# MODERA APARTMENTS

CITY OF SEATTLE DESIGN REVIEW

RECOMMENDATION MEETING

DPD PROJECT #3017791

# RESPONSE TO EARLY DESIGN GUIDANCE

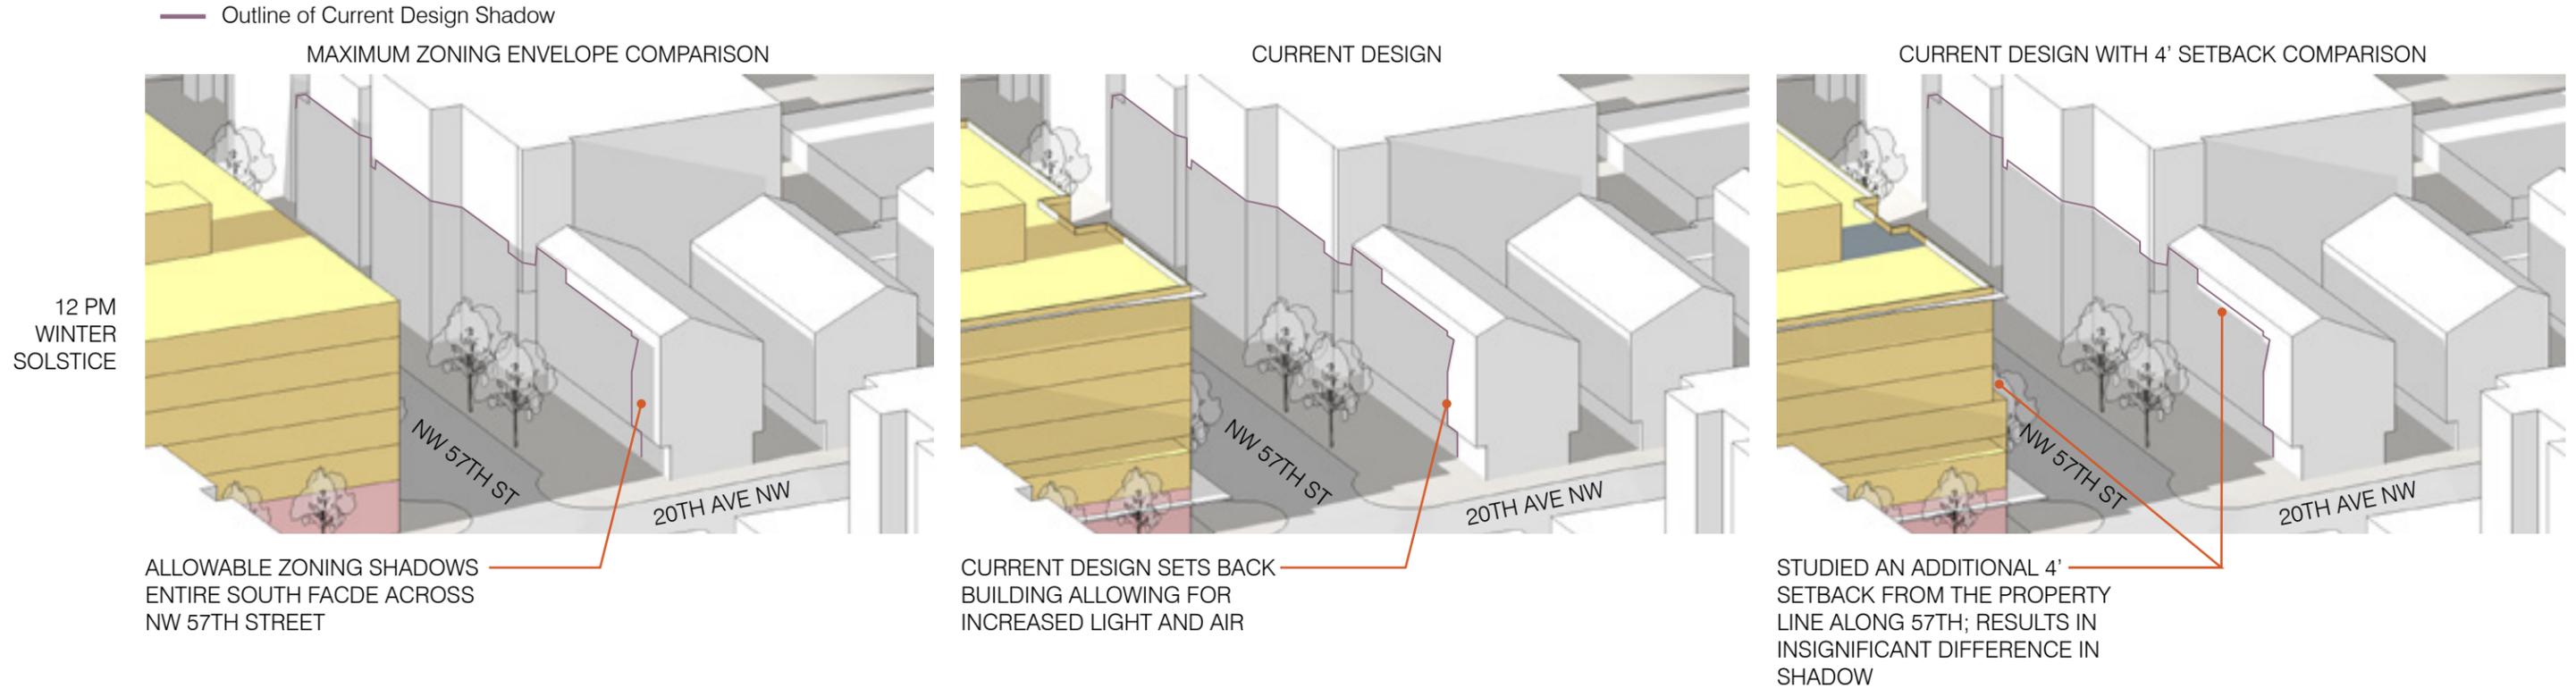
The Board agreed that the preferred Option C is the strongest massing concept and should be further developed. (CS2-D)

The Board discussed at length how the courtyard configuration might be situated to help minimize massing impacts, as well as light and shadow impacts.

a. The Board would like to see a setback along NW 57th Street to allow greater light and air to the neighbors directly across the street to the north, as well as visual interest and relief from the massing. The Board requested that solar studies be completed that inform

the design strategy that addresses these two concerns. Possible strategies might include setting back the upper floors, modulation, or notching out a portion of the building to accommodate an upper level courtyard. (CS1.B2, CS2.D, DC2.A2, DC2.D1, DC2.D2)

b. The Board stressed that maintaining the street wall at the lower levels along NW 57th Street would be appropriate and that the upper two to three levels should be set back to achieve improved light access. (CS2.II.iii)

Option 'C' - Alt. from the EDG meeting has been developed as the preferred scheme and per the DRB's recommendation. This scheme includes a two story commercial feel massing at the corner of 20th Avenue NW and NW 57th Street. Live-Work occupies street frontage on 20th Avenue NW, NW 57th Street, as well as the semi-private pedestrian walkway facing the Greenfire campus. The residential lobby and leasing is located at the corner of NW 57th Street and 20th Avenue NW. The building corner is expressed to enhance the gateway feeling of NW 57th Street with its tree lined street that draws pedestrians toward the Ballard Commons and Municipal Park to the West.

a. The proposed design allows increased light and air to neighbors directly across the street by; setting back the façade along 20th Avenue NW above Level 2, modulating the façade with deeper notches along NW 57th Street, and setting back the building along the West property line. The metal panels along the north facade will provide more reflective light to neighbors to the North. The shadow studies indicate that the proposed design would have an insignificant effect on newly created shadowing for neighbors to the north. Note that the large existing streets on the North and South side of NW 57th Street, not shown in our shadow studies, also have a significant impact on shadowing already occurring to neighbors on the North.

b. The proposed design maintains a street wall at the lower levels and provides increased modulation at Live-Work entries along NW 57th Street to add variety and interest. The deeper modulations on the NW 57th Street facade improve light access.

(See Solar diagrams above; additional studies provided on page 46-47)

## 6. SERVICE AREA

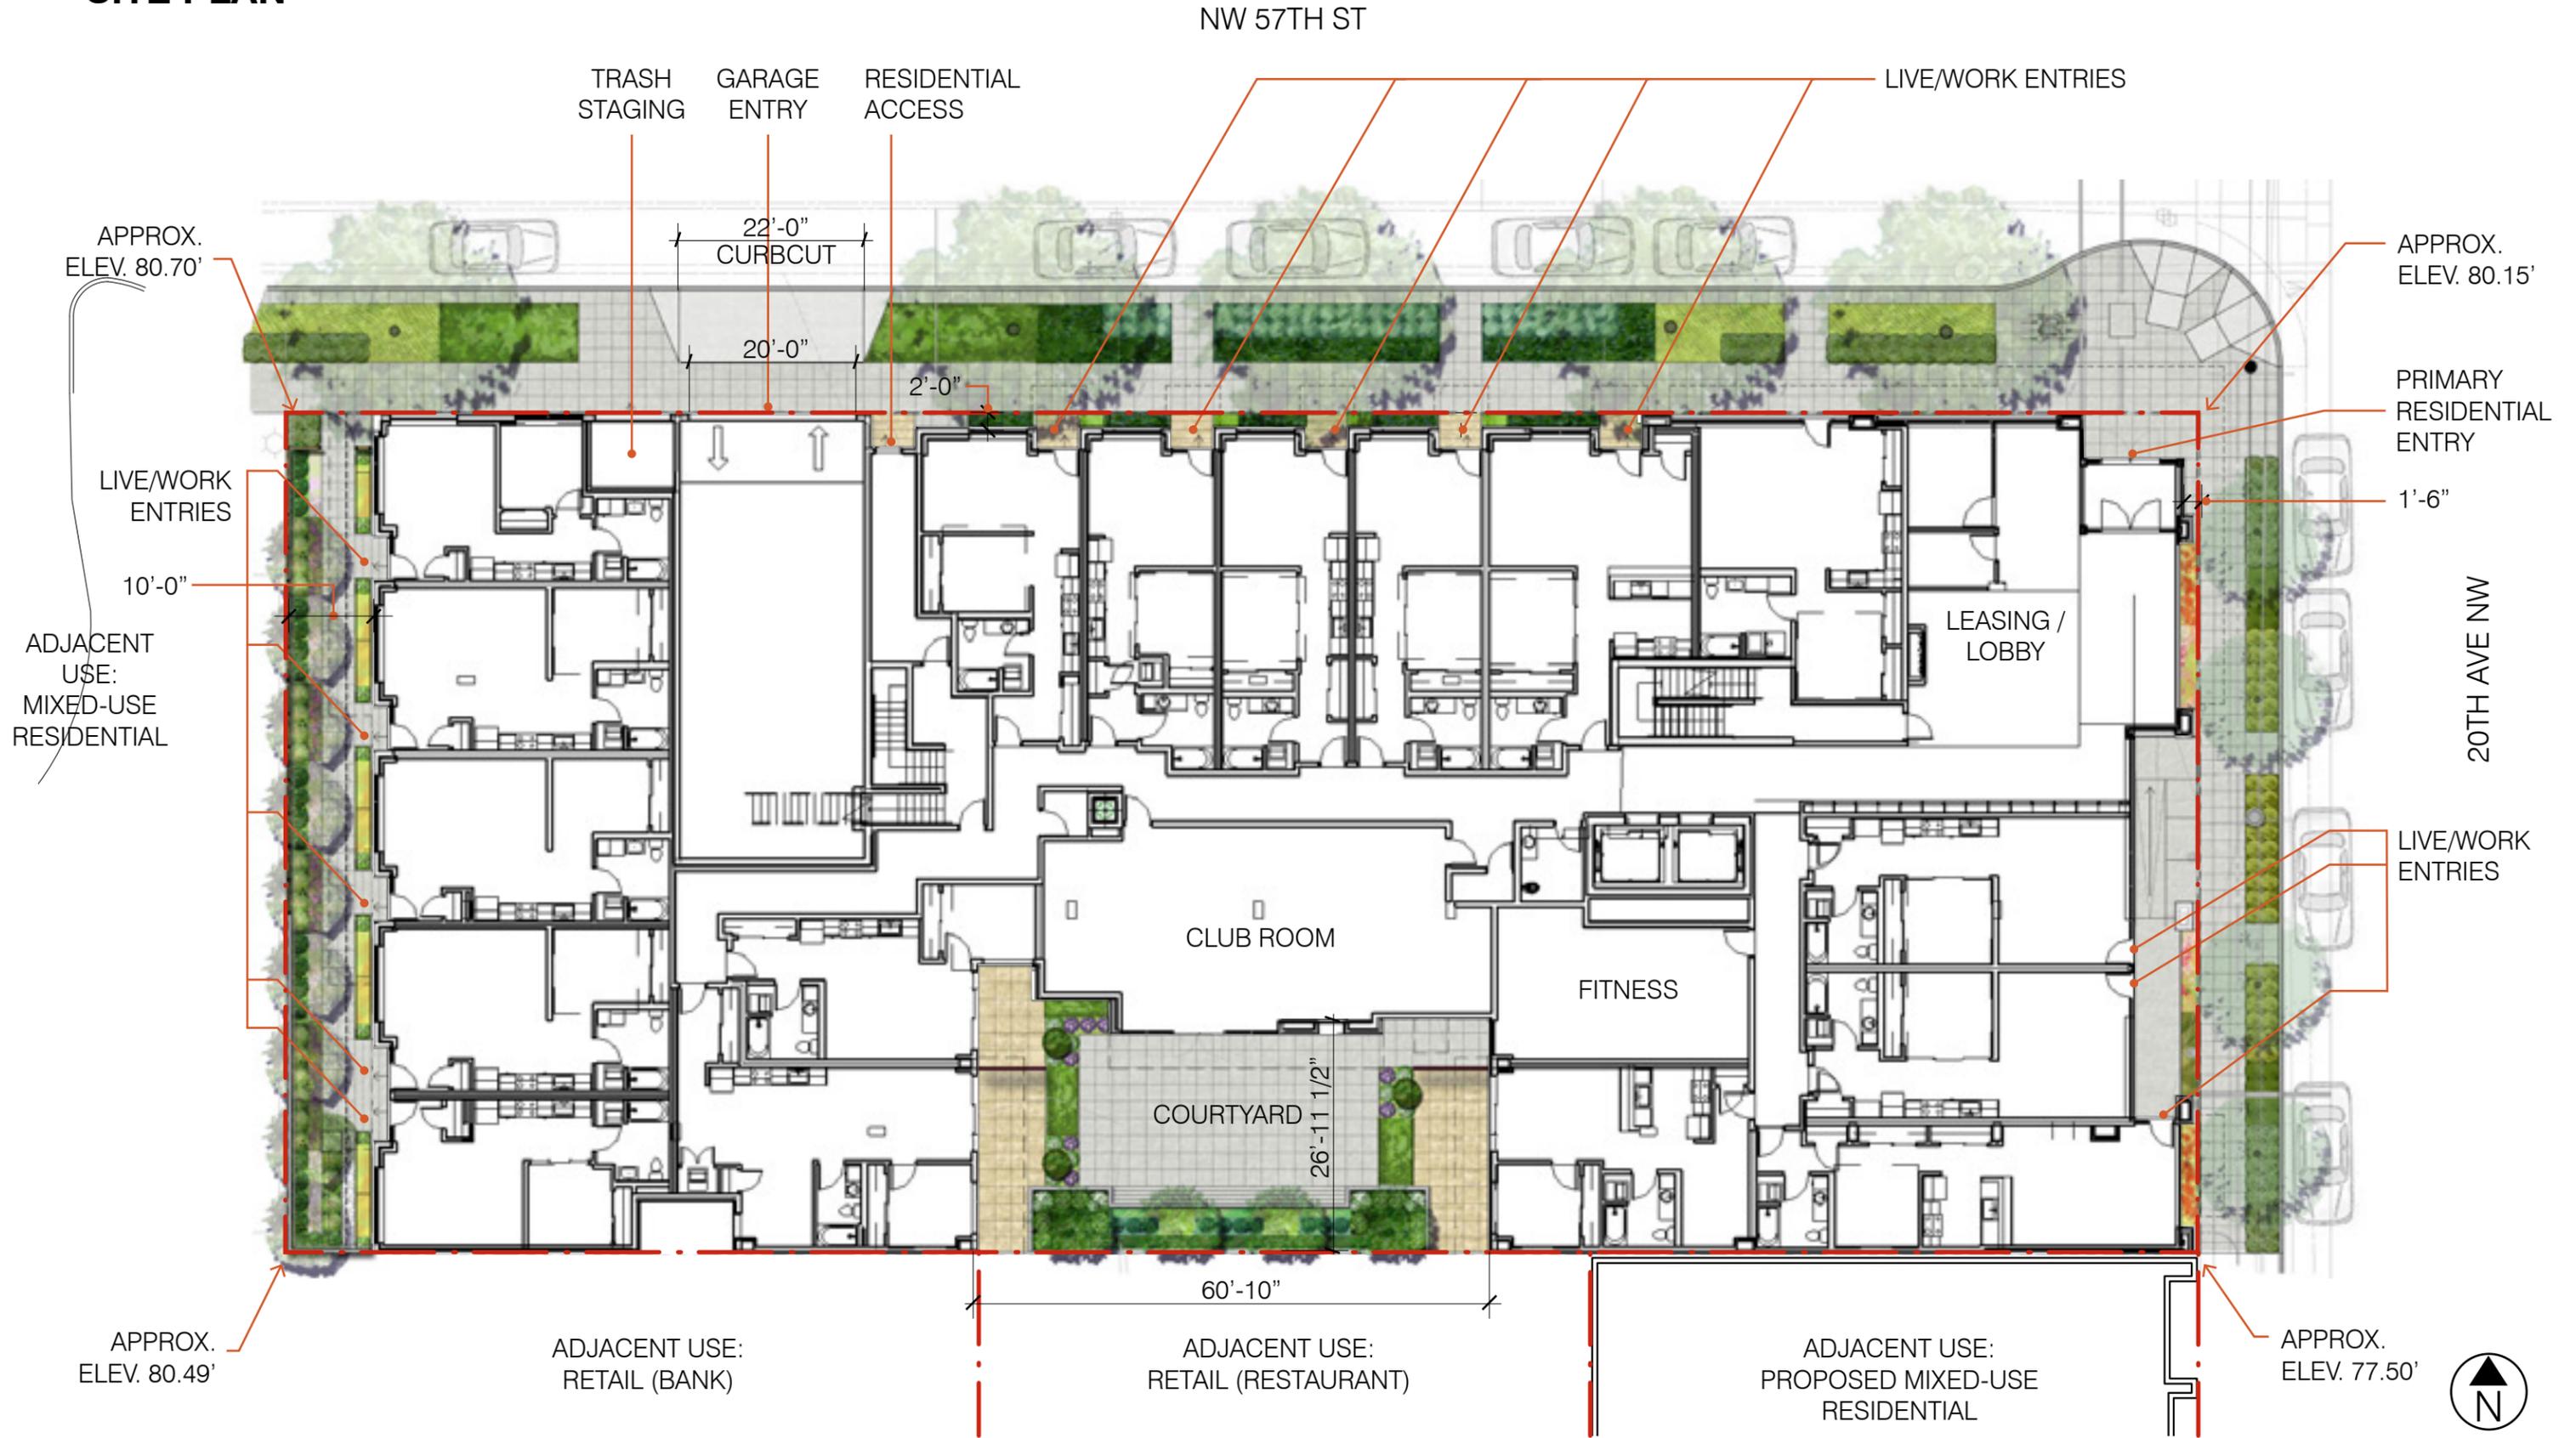
*The Board recommended that the trash and staging area be accommodated within the building at ground level. Such provision would eliminate the need for the departure request from slope. (DC1.C4.)*

The proposed design contains a trash/ recycling collection area on level P01 and a trash / recycling staging area on Level 1. The building management will move trash / recycling containers to the staging area on collection day. No departure request is sought at this time.
